2.5 Geology, Seismology, and Geotechnical Engineering

In Section 2.5, “Geology, Seismology and Geotechnical Engineering,” of the site safety evaluation report (SSAR), the applicant, System Energy Resources, Inc. (SERI), provided a detailed description of the geological, seismological, and geotechnical engineering properties of the early site permit (ESP) site. In this safety evaluation report (SER), Section 2.5.1, “Regional Geology,” describes basic geological and seismological data, especially the data published since 1986 for the area within a 200-mile radius of the ESP site, and presents updated seismic sources. Section 2.5.2, “Vibratory Ground Motion,” evaluates the vibratory ground motion for the ESP site and analyzes the safe-shutdown earthquake (SSE) ground motion. Section 2.5.3, “Surface Faulting,” describes the potential for surface faulting at or near the surface of the ESP site. Section 2.5.4, “Stability of Subsurface Materials and Foundations,” presents the results of site geotechnical investigations and discusses the stability of subsurface materials and foundations. Section 2.5.5, “Stability of Slopes,” defers the analyses for slope stability at the site and dam perf

(Figures 2.5.4-5 through 2.5.4-14) (Updated final version of SSAR Figures 2.5-87 and 2.5-96)

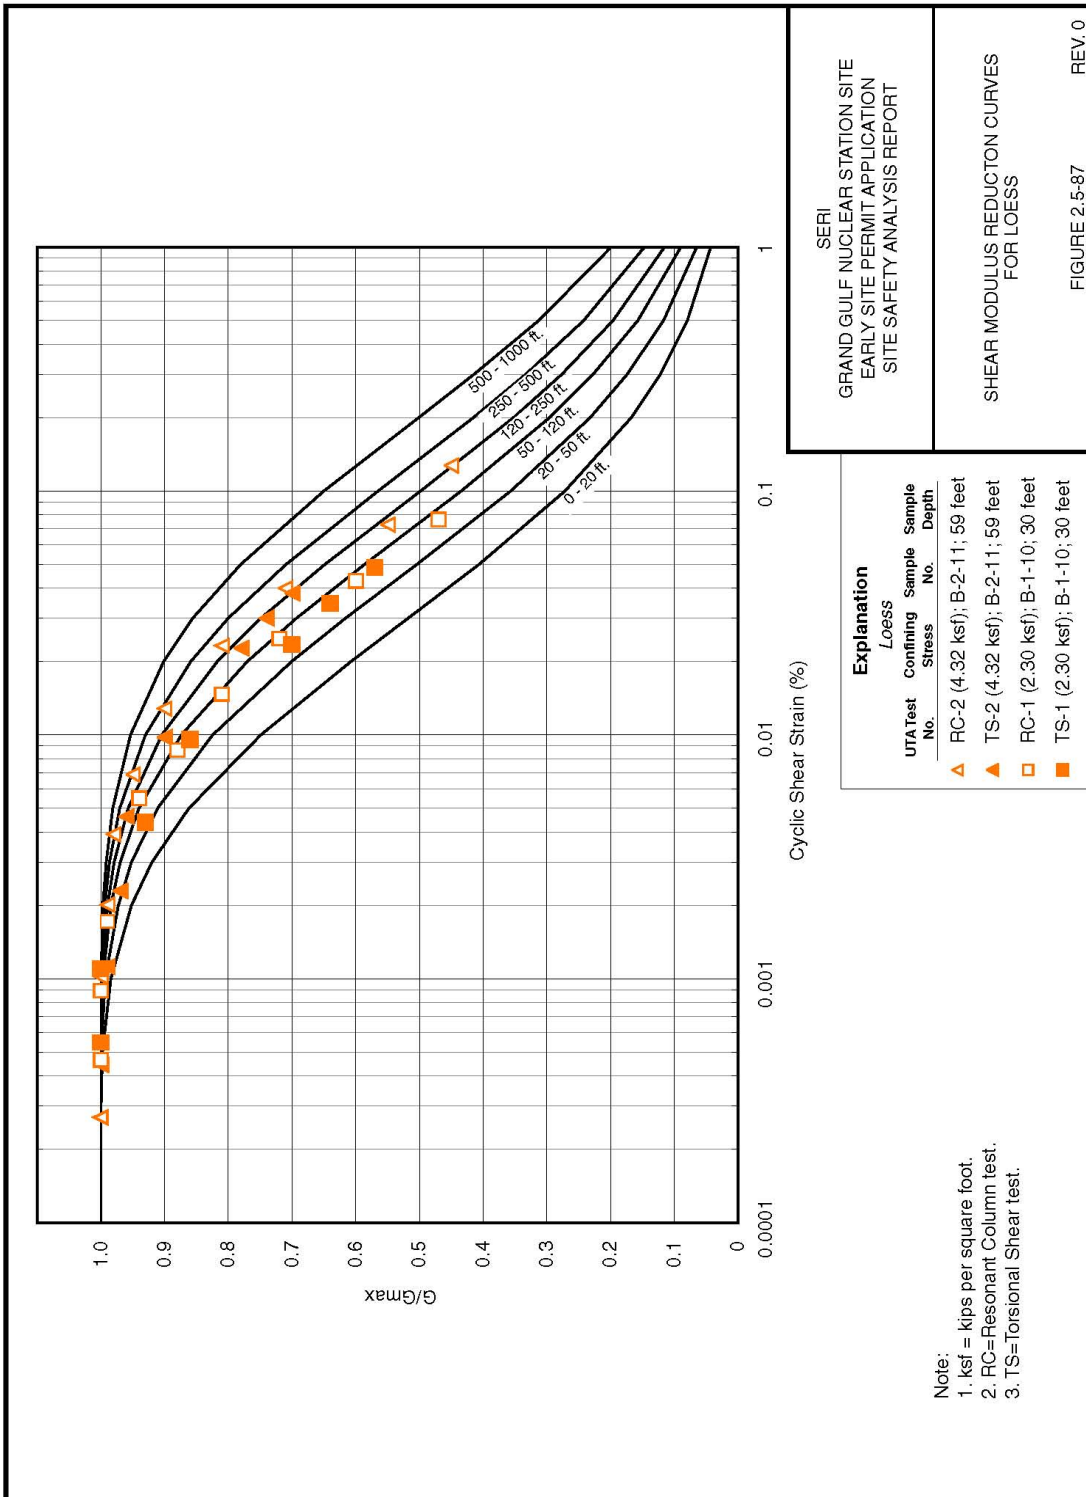
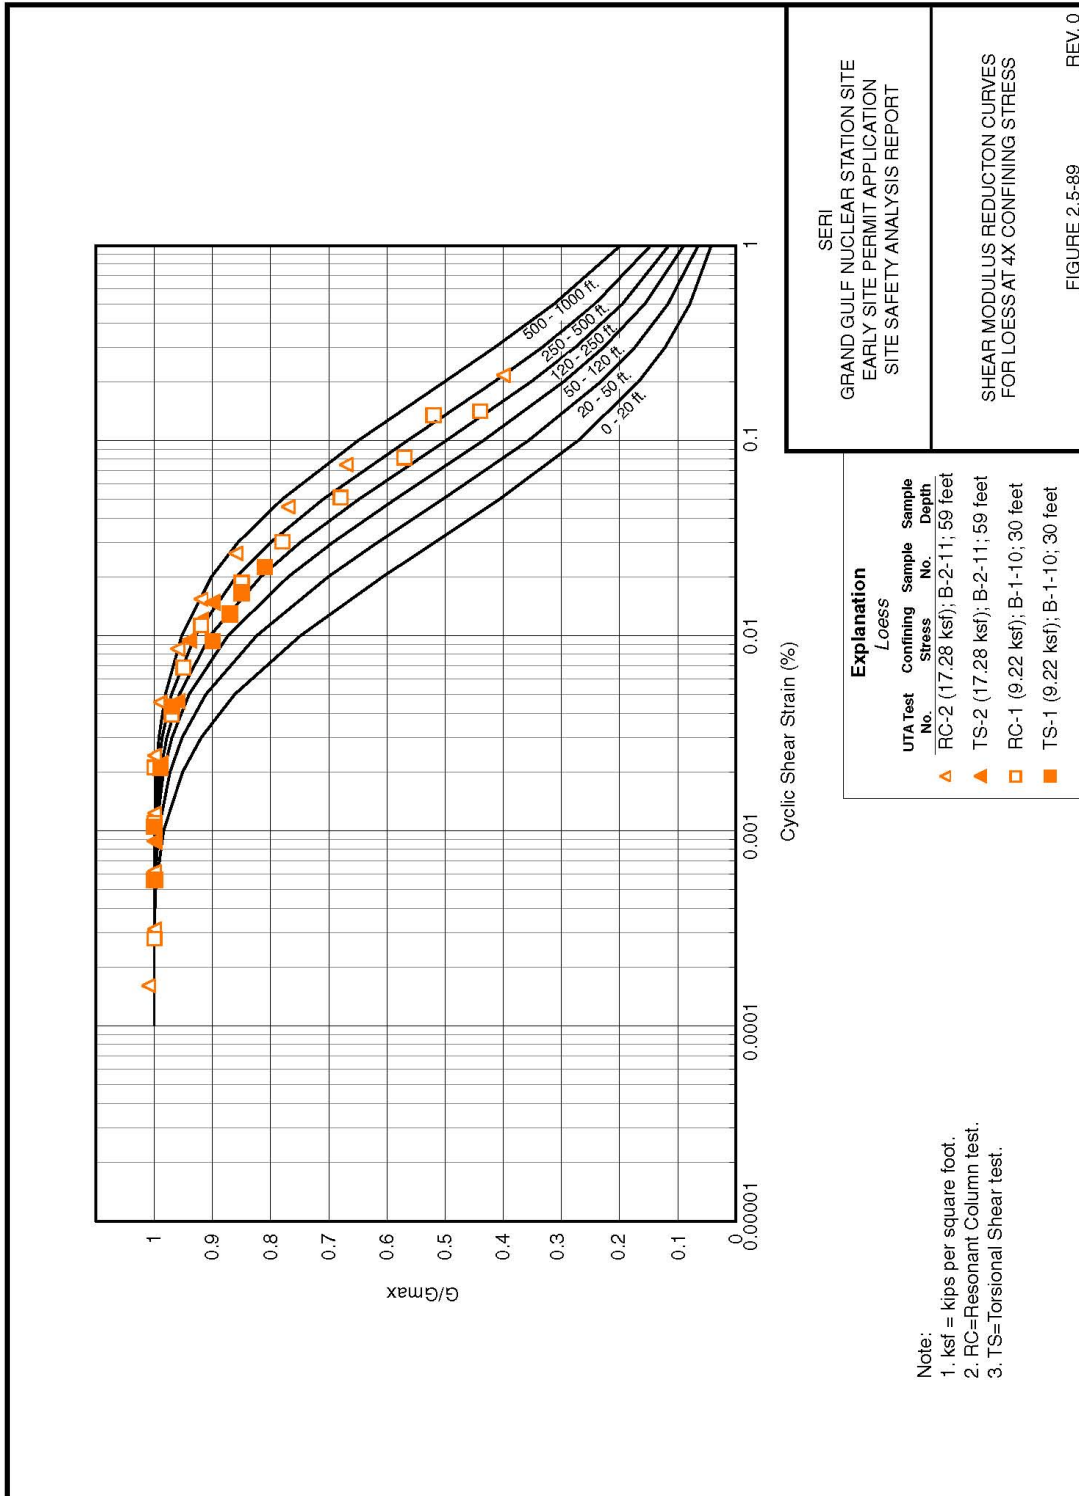
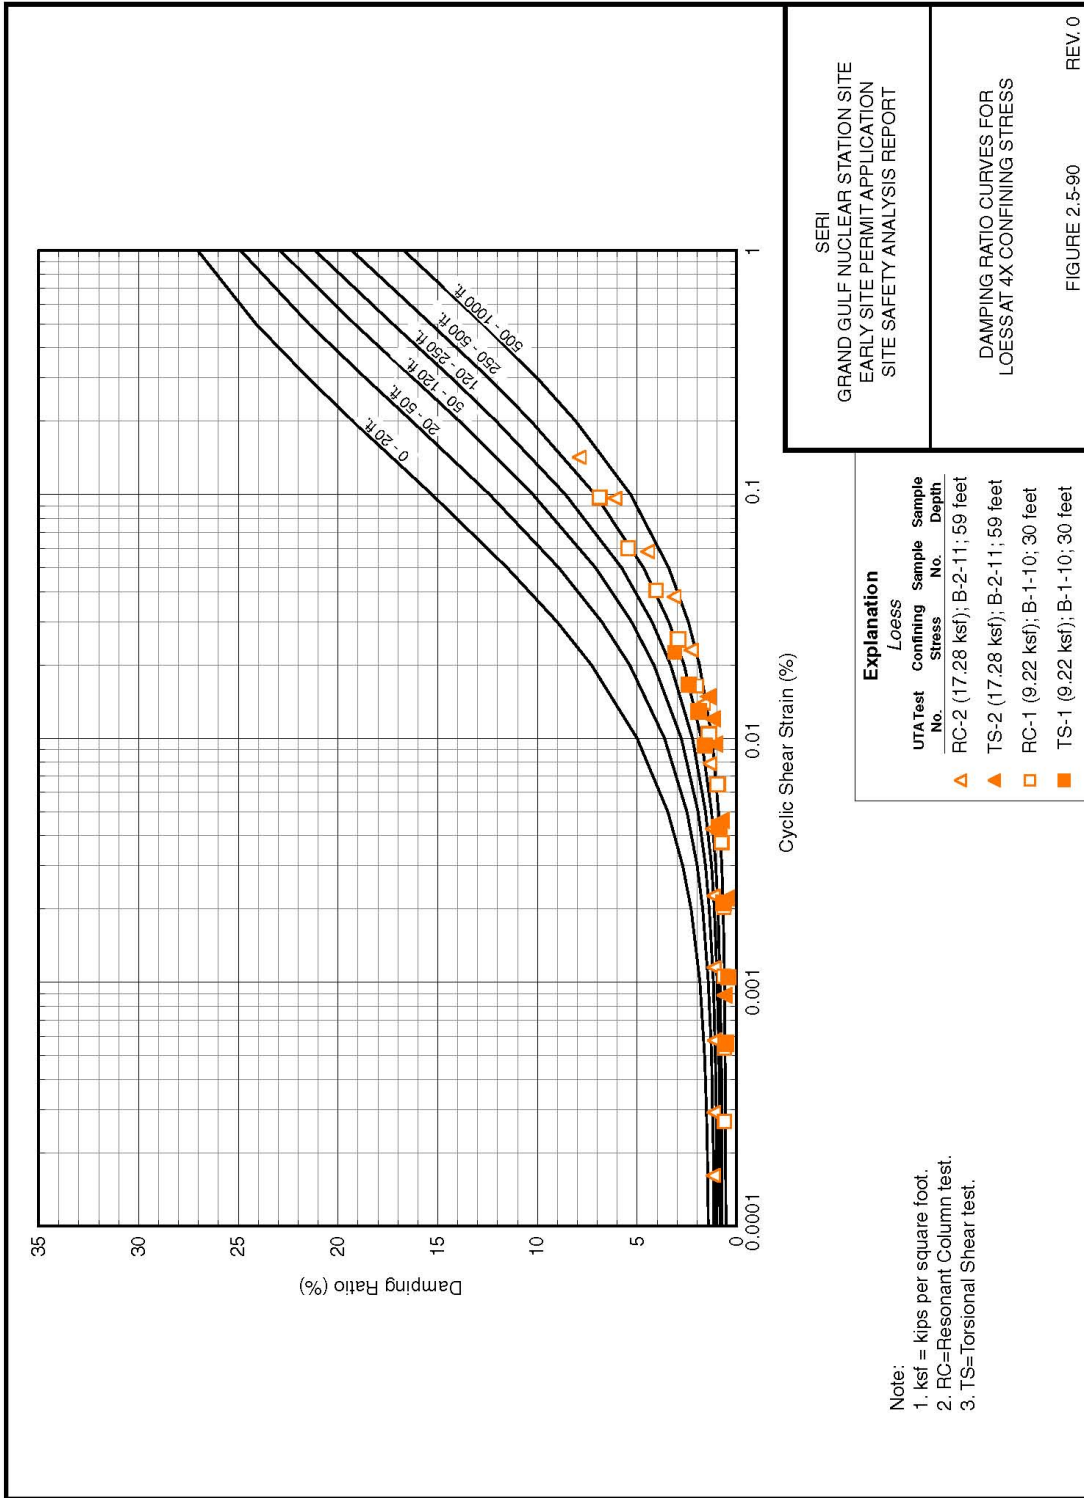
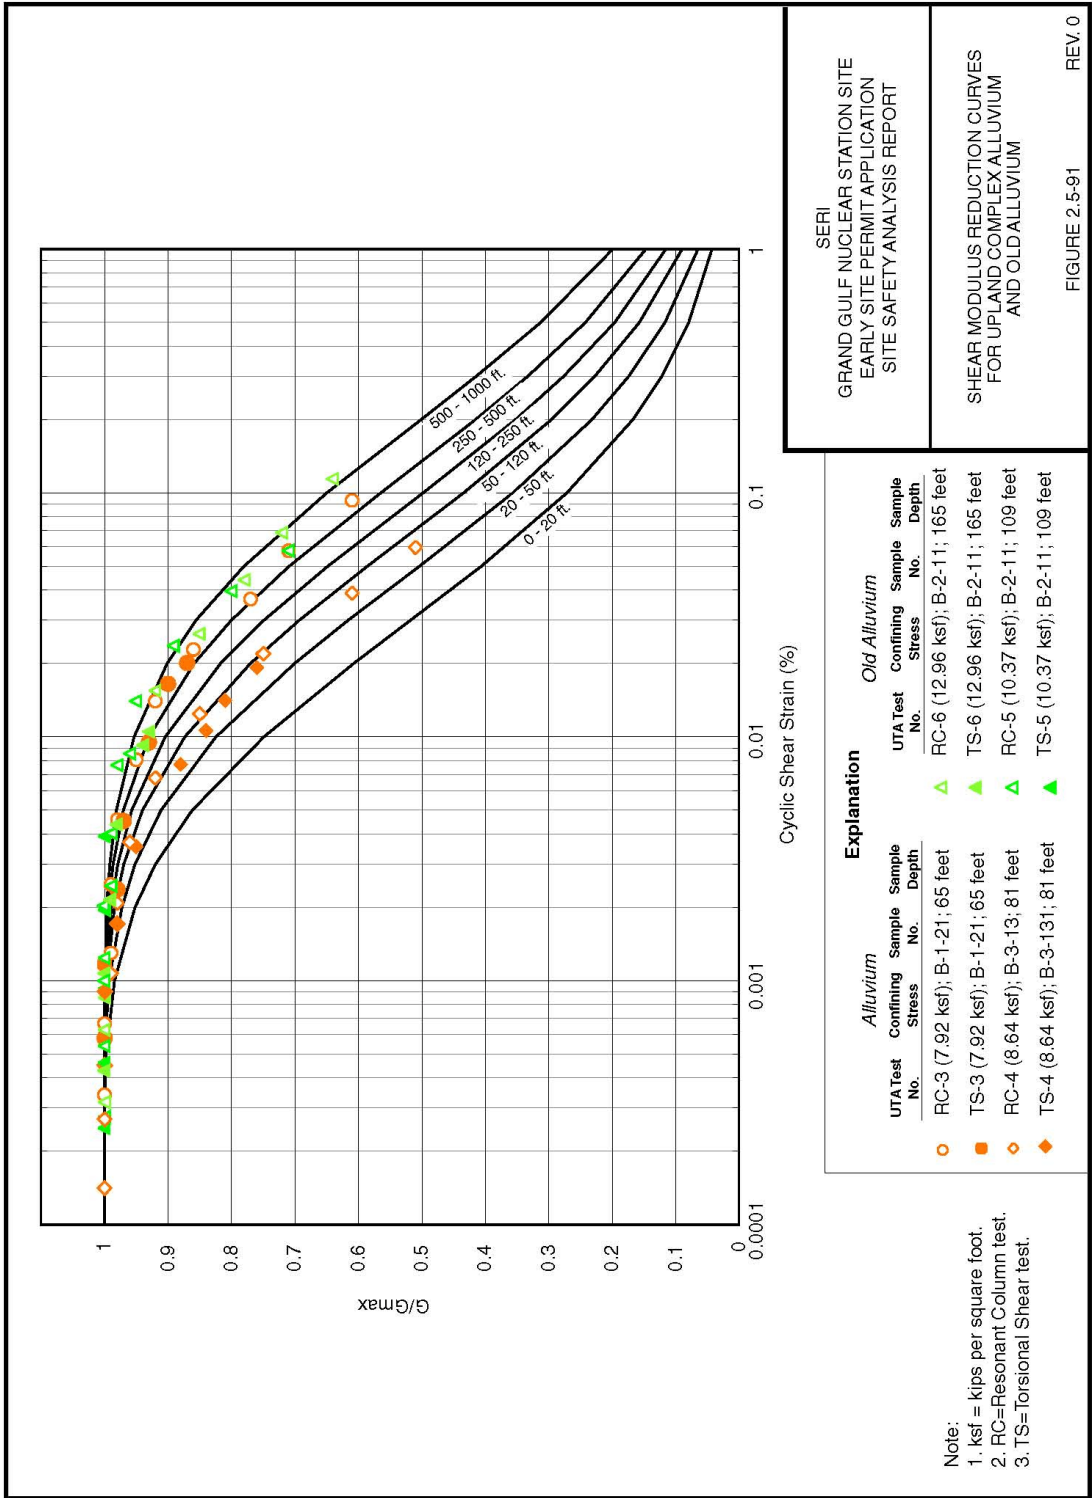
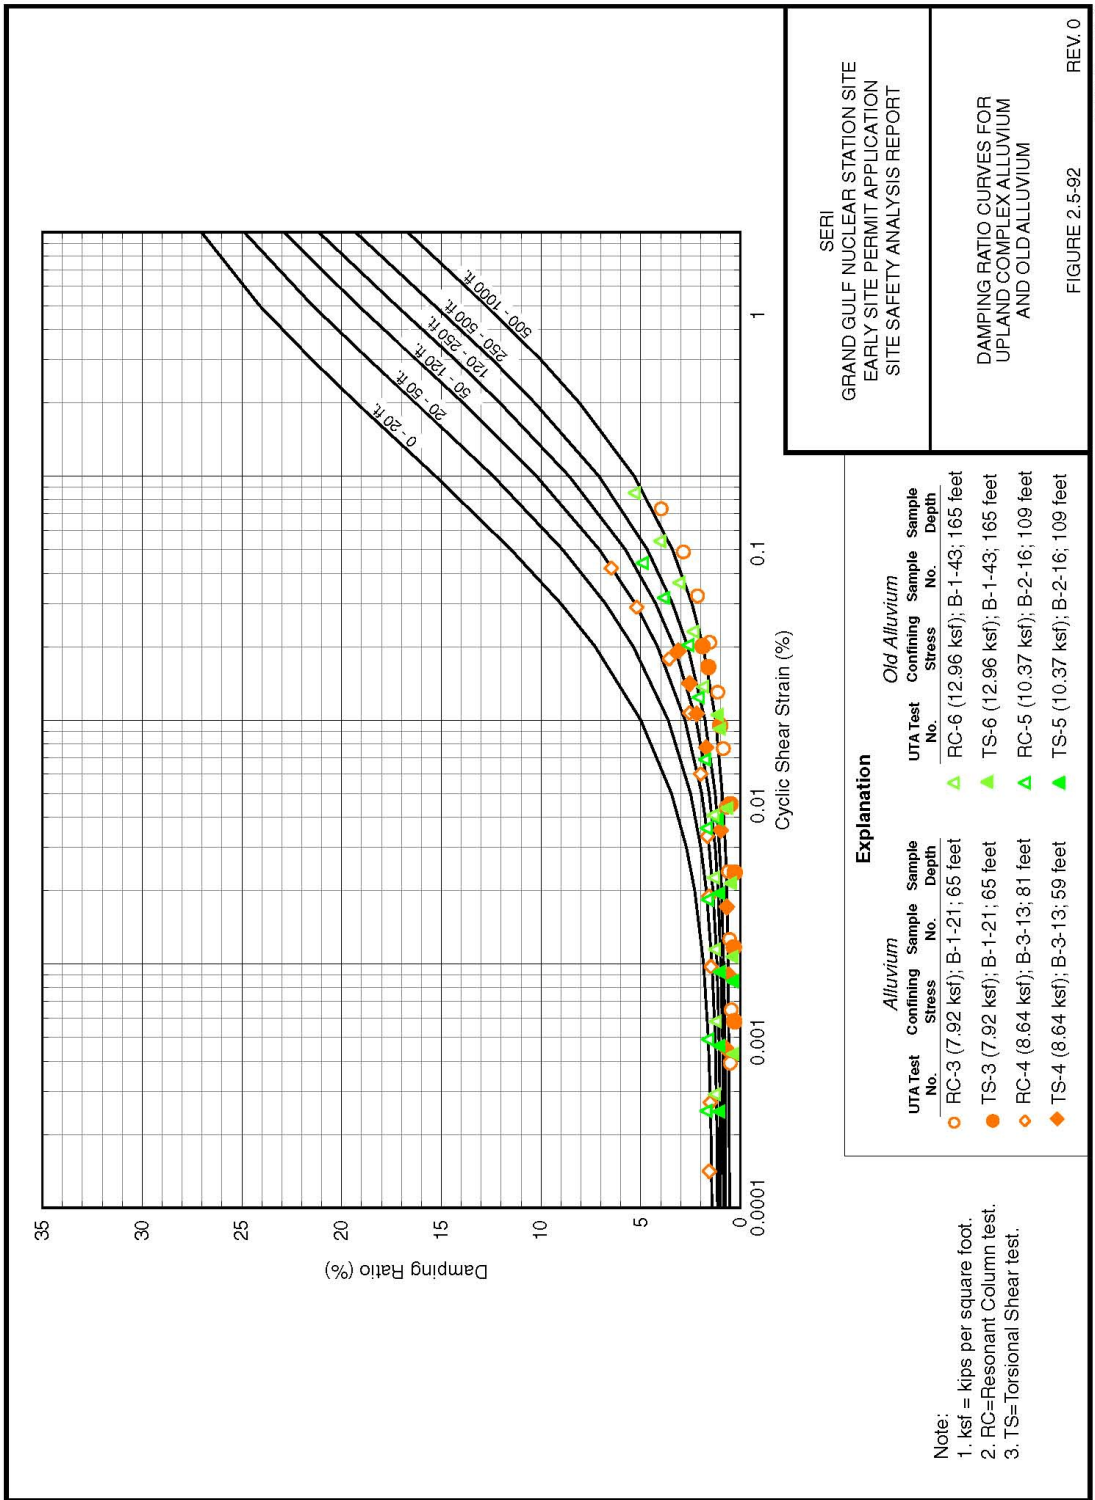
- Section 11.0 of ER-02 suggests that the laboratory results for specimens UTEXAS 1, 2, and 6 should be corrected to account for the effects of sample disturbance and/or underestimation of effective confining stress.

In RAI 2.5.4-7, the staff asked the applicant to provide its rationale for not incorporating these effects in the site response calculations and to evaluate the potential impact of these modifications on the computed surface UHS. In its response, the applicant referred to its response to RAI 2.5.4-6 and stated that the analysis and selection of the appropriate EPRI-TR curves for shear modulus reduction and hysteretic damping fully account for the effects of possible disturbance to the test specimens resulting from stress release during sampling, as well as possible movements during testing. The applicant considered the effects of sample relaxation by examining the results from testing soils at both the estimated in situ confining stress and 4 times the estimated in situ confining stress. The applicant plotted these two data sets together on the EPRI-TR base curves as shown in Figures 2.5.4-5 through 2.5.4-12, which replicate SSAR Figures 2.5.4-87 to 2.5-94 and Figures 2.5.4-13 and 2.5.4-14. The two data sets were weighted to select the most representative EPRI-TR curve.

The applicant also stated in its response that SSAR Section 2.5.4.1.7 presents the results of the dynamic laboratory tests plotted on the families of EPRI modulus reduction and damping curves for loess, Upland Alluvium, and Old Alluvium. However, because it did not indicate which of the EPRI curves should be selected for the site response analyses, the applicant will revise these SSAR figures to indicate the recommended curves used in the site response analyses. The applicant also stated that SSAR Section 2.5.4.1.7 discusses the rationale for adopting the EPRI curves. Specifically, the shape of the curves defined by the site-specific laboratory tests are similar to the shape of the EPRI curves. The comparison of the laboratory and EPRI-TR curves indicates that the raw laboratory data show less modulus reduction and lower damping values than the EPRI curves for the same depths. The applicant also explained that this is likely because EPRI developed these curves for normally consolidated Holocene silty and clayey sands, whereas the soils at the ESP site are both older and overconsolidated. In addition, the applicant noted that the laboratory test results must be adjusted for the effects of stress relief sample disturbance. As indicated in SSAR Table 2.5-26, the ratio of the shear wave velocities measured in the laboratory versus the field is generally less than unity. The ratio of the shear wave velocities measured in the laboratory for specimens consolidated to 4 times the estimated in situ stress versus the field-measured velocities are on the order of unity. This suggests that the additional sample consolidation produces results that better match the in situ field conditions of these soils.
